SUBJECT: Forwards addl info refire protec prog for subj facil in response to Items #8, #12 of NRC 780313 ltr. Info covers lube oil spill control sys for reactor coolant pumps & flame retardant coatings.

H. B. ROBINSON STEAM ELECTRIC PLANT UNIT NO. 2
DOCKET NO. 50-261
LICENSE NO. DPR-23
ADDITIONAL INFORMATION - FIRE PROTECTION PROGRAM

H. B. ROBINSON UNIT NO. 2
FIRE PROTECTION

Figure No. 1

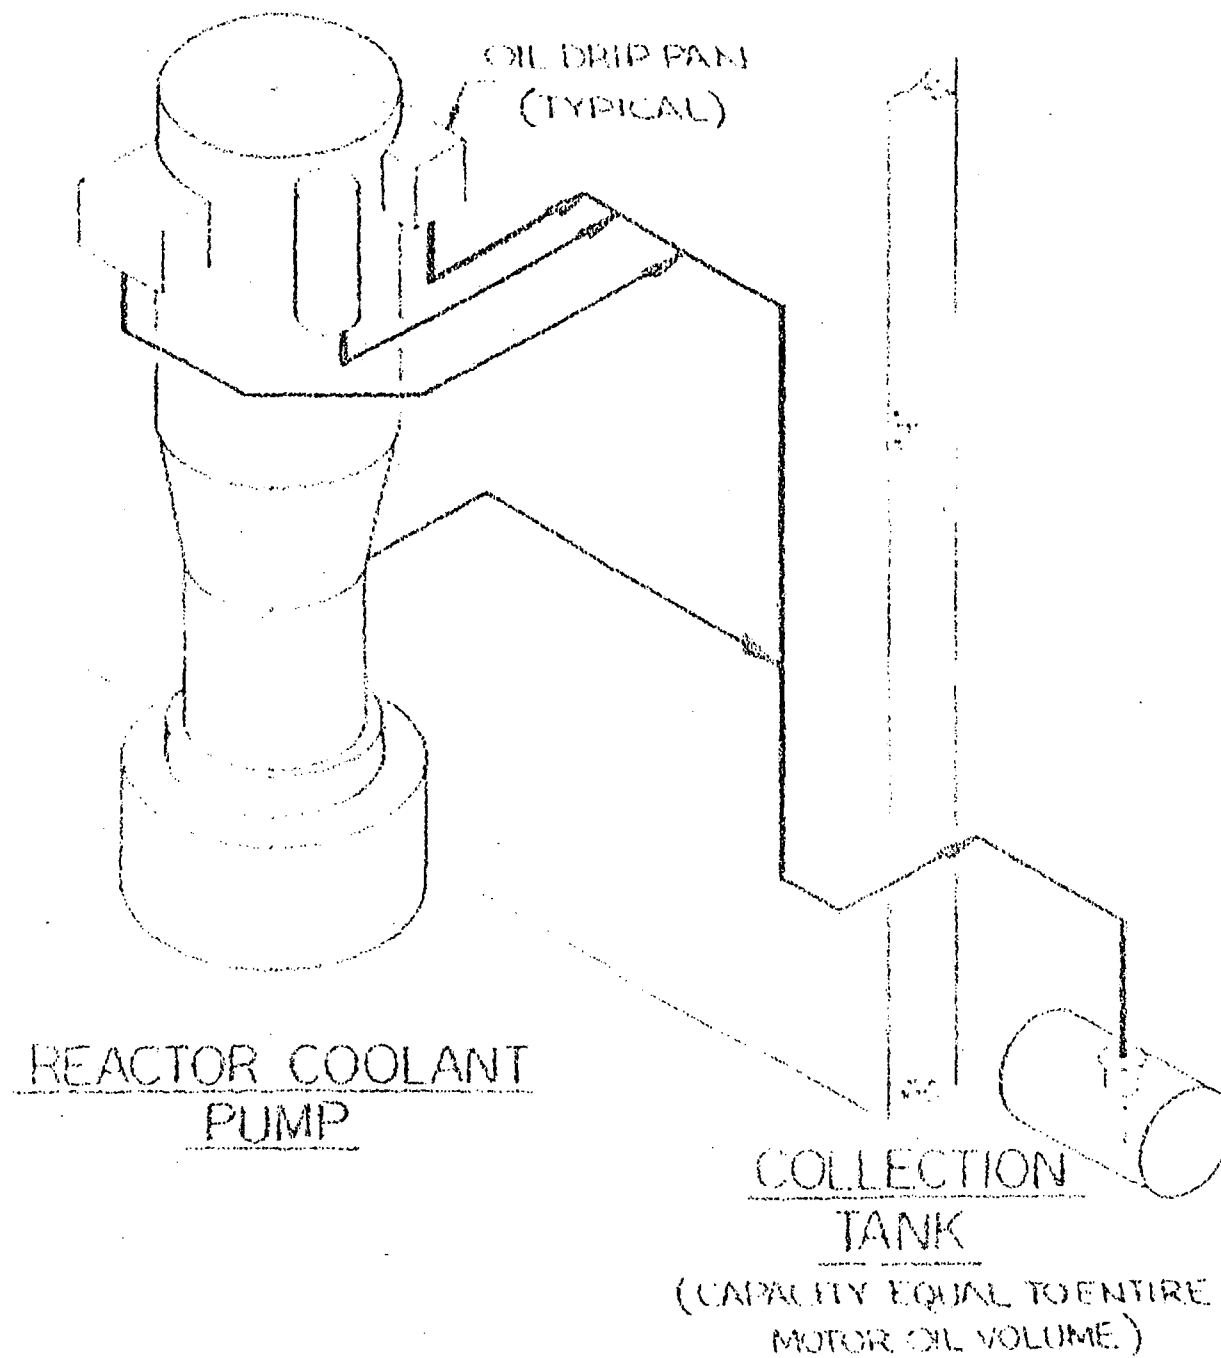
8. Lube Oil Spill Control System for Reactor Coolant Pumps

The reactor coolant pump motor lube oil spillage collection system is designed to contain spilled oil from gasket leaks or failures associated with the motor lube oil system. Drip pans and catch basins attached to the motor are designed to collect any spilled or leaked oil. All oil that is collected is routed to a gravity-fed reservoir at each pump. Each reservoir will be sized to accommodate the oil contained in each motor. In the event of oil leakage, no fire will occur because all oil will be removed from any potential ignition sources. Attached Figure No. 1 is a drawing of the proposed system.
